Memorandum

Subject: Midgard Self Storage Facility – Alternate 1-Hr Fire Rated Partition Detail

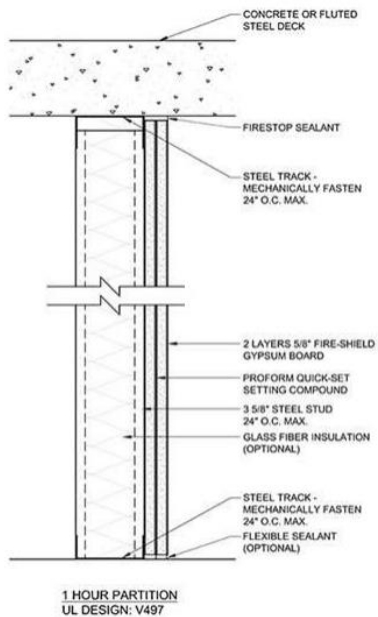
I am with Hendrick, the Architectural firm working on the project for Midgard. Due to onsite constructability concerns, brought to our attention, we are proposing an alternate 1-hr fire rated partition detail. The currently permitted drawings call for a 1-hr UL U419 detail, which has the 5/8" Type X drywall on both sides. We are proposing to use the UL V497 detail, with two layers of 5/8" Type X bonded together, per detail below.
